# Oberon Renewable Energy Project

## PUBLIC SCOPING REPORT

**August 2021**

Map shown at the BLM Zoom scoping meeting on April 13, showing proposed solar fields cutting off wash flow from connecting washes coming off the Chuckwalla Mountains to the south—overlapping and even preferring tortoise Critical Habitat and multispecies linkage.

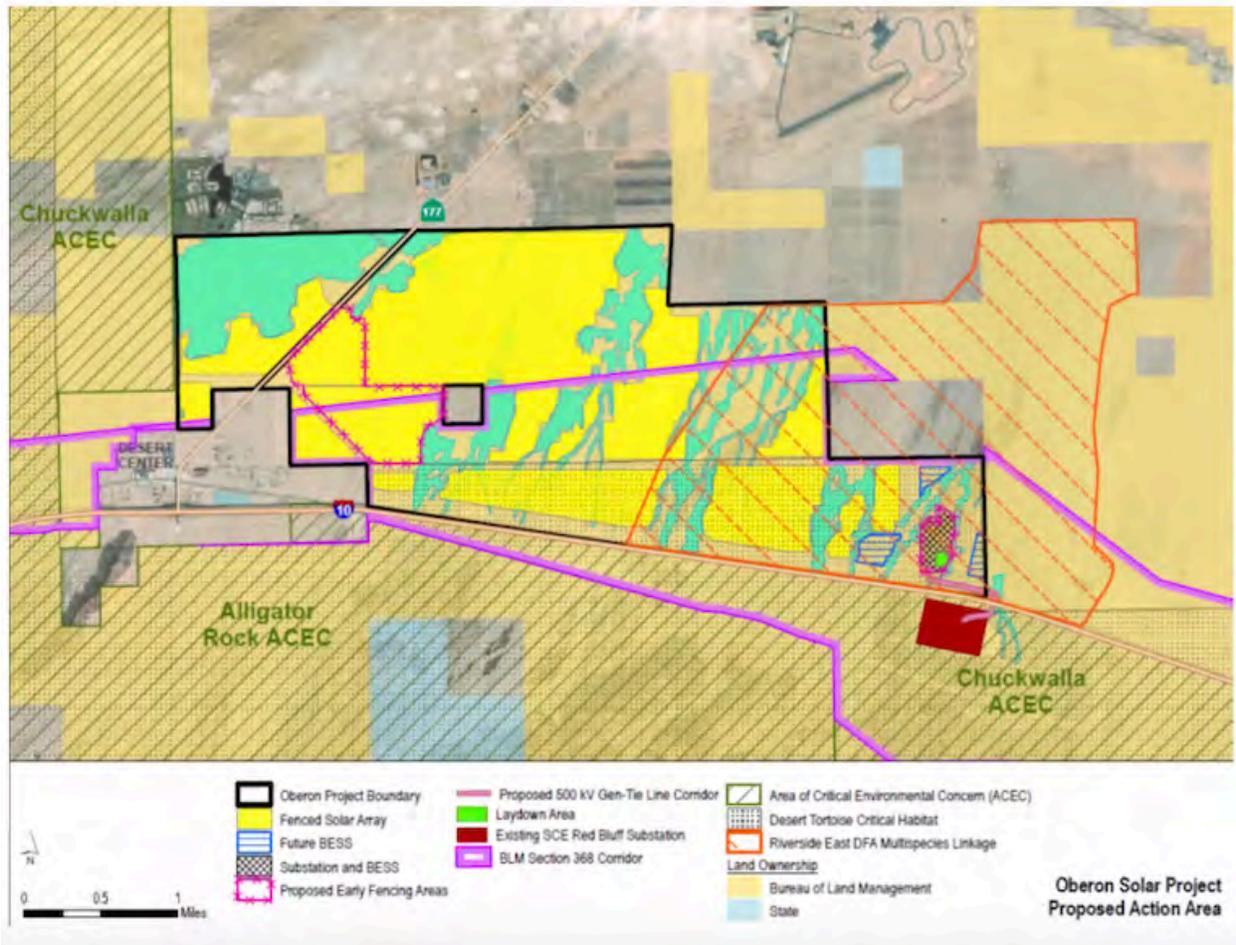
A discussion of how connectivity of wash plant communities needs to be included, because the solar field would block flow of flood waters in washes, potentially cutting off water-dependent microphyll woodland and killing patches on the other side of the proposed solar fields. This area receives monsoonal summer thunderstorms that are at times heavy, with flash floods flowing down washes into basin playas. Analysis of stormwater runoff needs to be undertaken related to the connectivity of microphyll habitats in ephemeral washes.

Map shown at the BLM Zoom scoping meeting on April 13, showing proposed solar fields cutting off wash flow from connecting washes coming off the Chuckwalla Mountains to the south—overlapping and even preferring tortoise Critical Habitat and multispecies linkage.

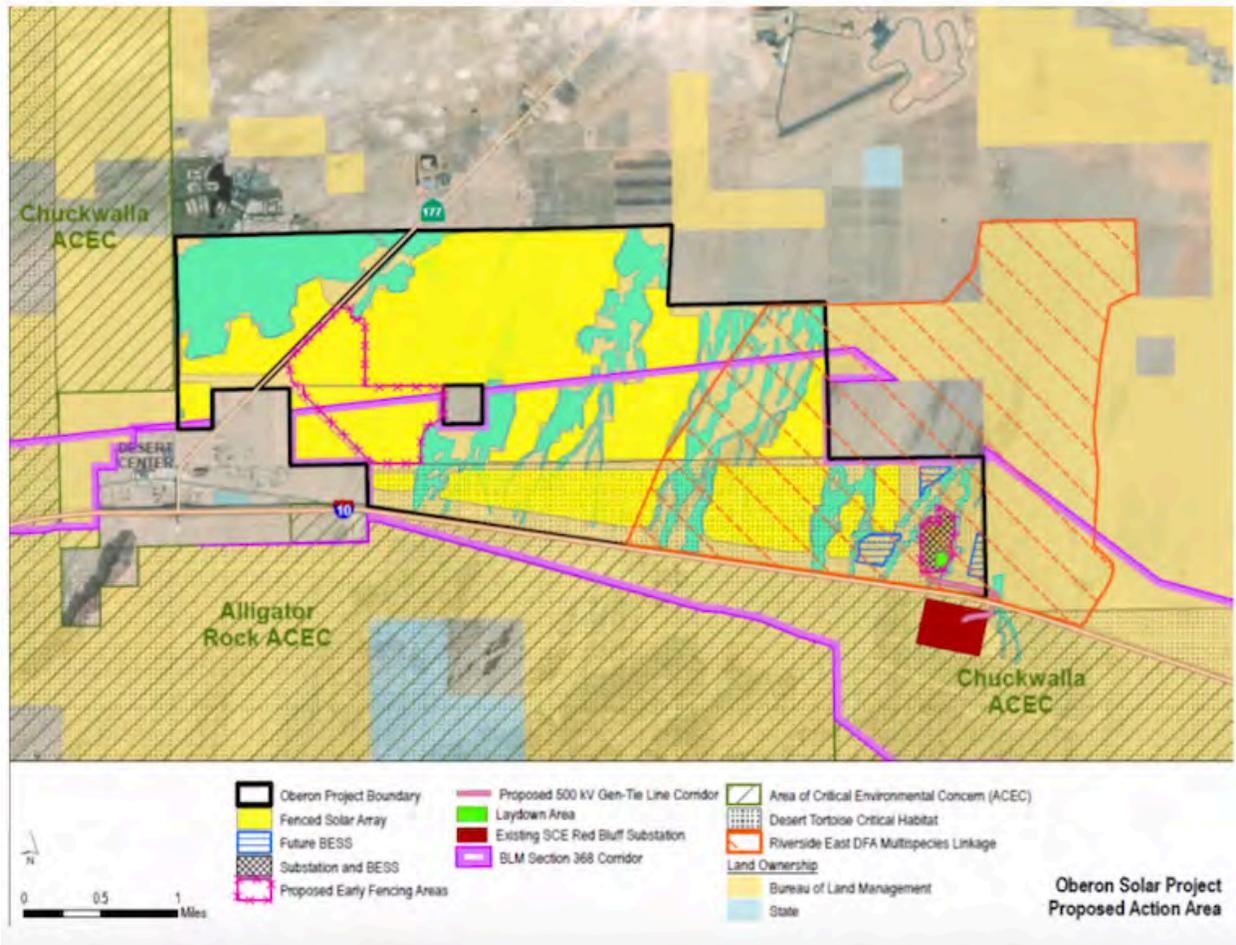
A discussion of how connectivity of wash plant communities needs to be included, because the solar field would block flow of flood waters in washes, potentially cutting off water-dependent microphyll woodland and killing patches on the other side of the proposed solar fields. This area receives monsoonal summer thunderstorms that are at times heavy, with flash floods flowing down washes into basin playas. Analysis of stormwater runoff needs to be undertaken related to the connectivity of microphyll habitats in ephemeral washes.
